The Commission has issued the enclosed Amendment No. 79 to Facility Operating License No. DPR-56 for the Peach Bottom Atomic Power Station, Unit No. 3. This amendment consists of changes to the Technical Specifications (TSs) in response to your applications dated September 30, 1980 and March 30, 1981, as supplemented April 24, June 30 and July 15, 1981.

PEACH BOTTOM ATOMIC POWER STATION, UNIT NO. 3

AMENDMENT TO FACILITY OPERATING LICENSE

Amendment No. 79
License No. DPR-56

Figure 3.5.K.2-- MCPR Operating Limit Vs. T
P 8X8R & PIA fuel

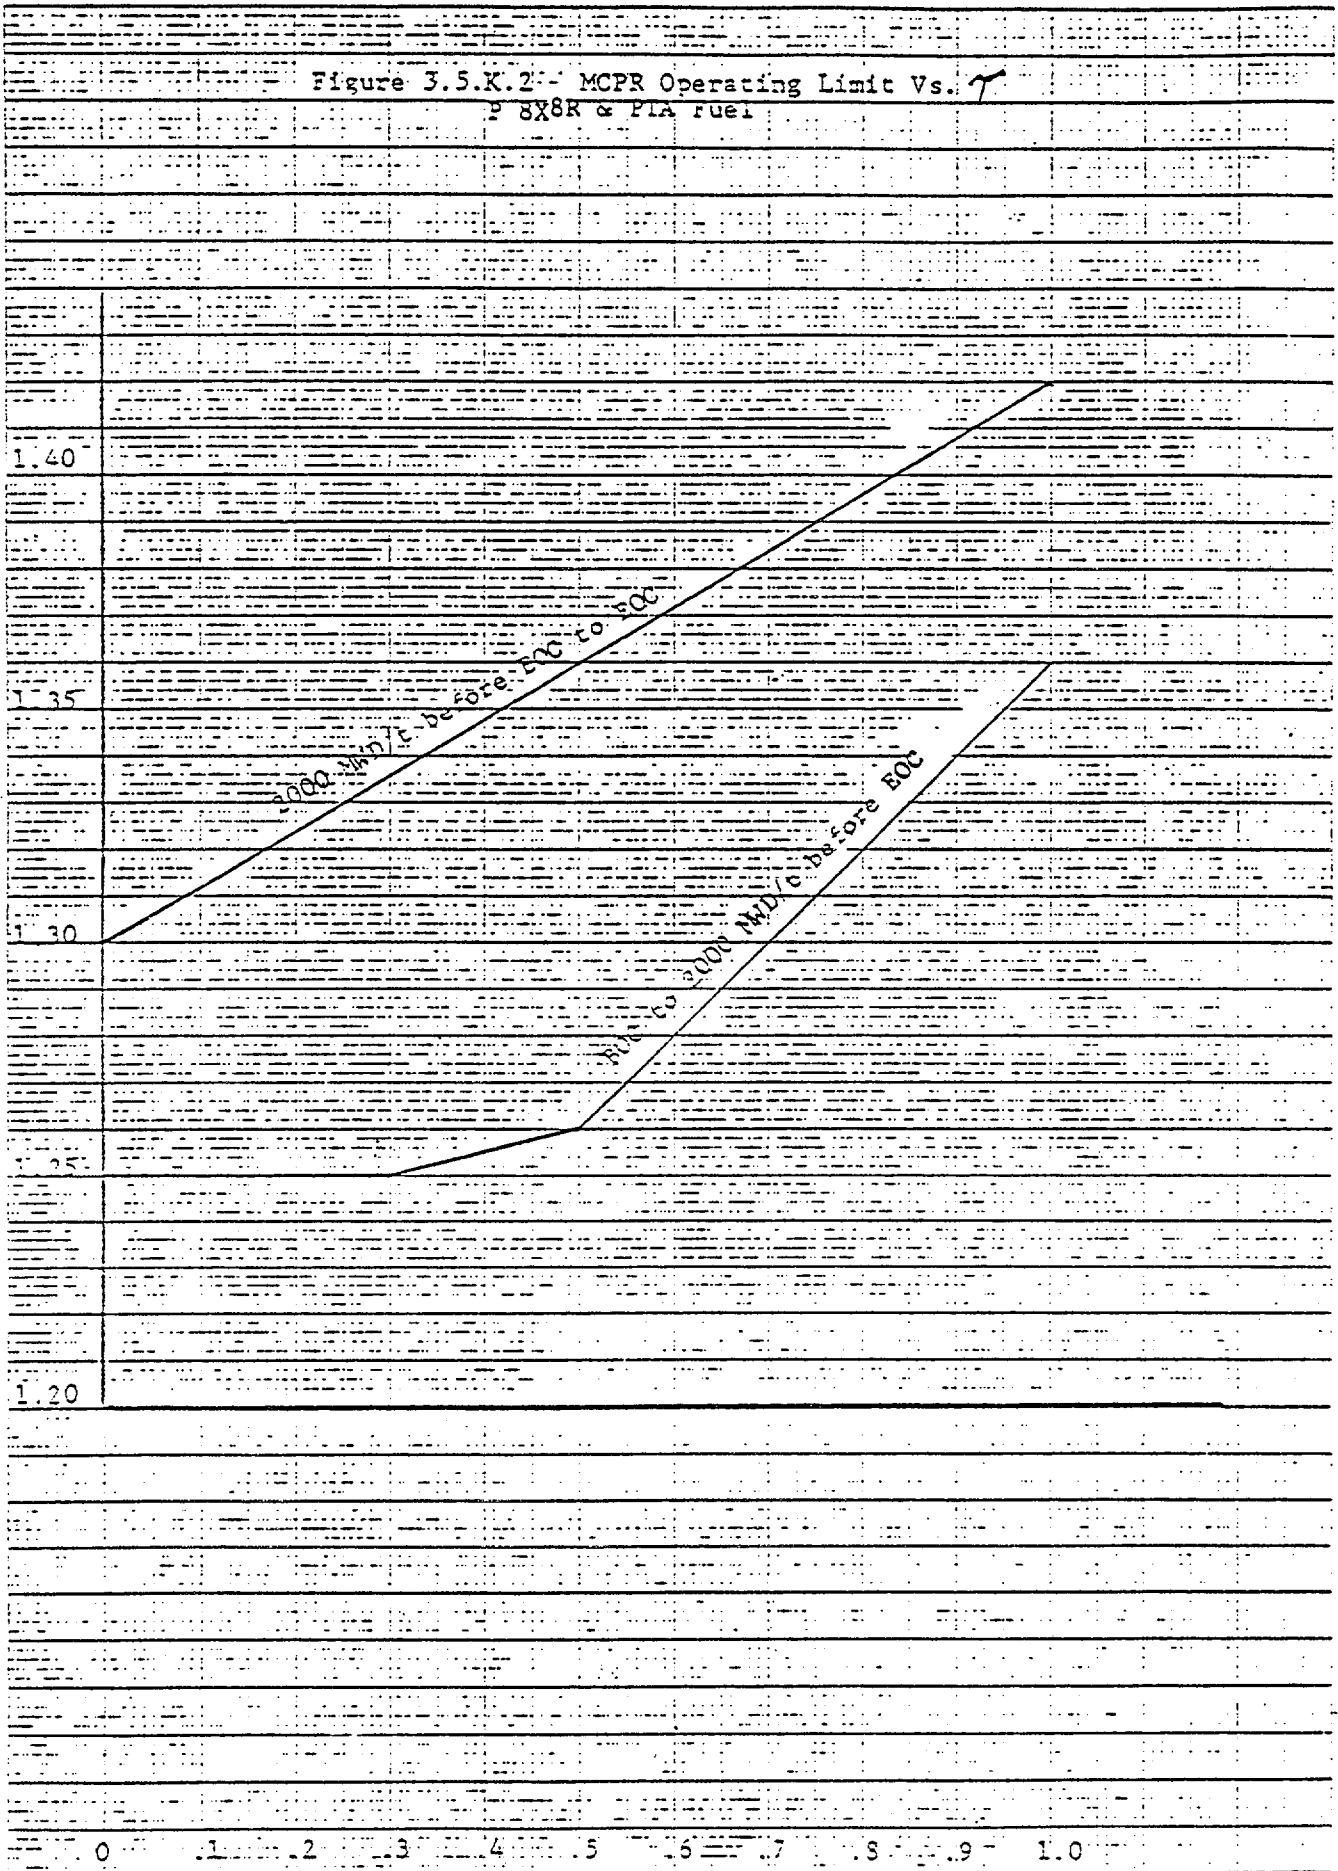
Based on our thermal-hydraulic design evaluation in this Safety Evaluation, changes in the TSs are found to be acceptable except that we have modified TS Figure 3.5.K.1, Page 142 (Ref. 3) MCPR operating limit vs. τ for 8x8 and 8x8R fuel. This modification makes the MCPR operating limit more conservative. This change was agreed to by the licensee.
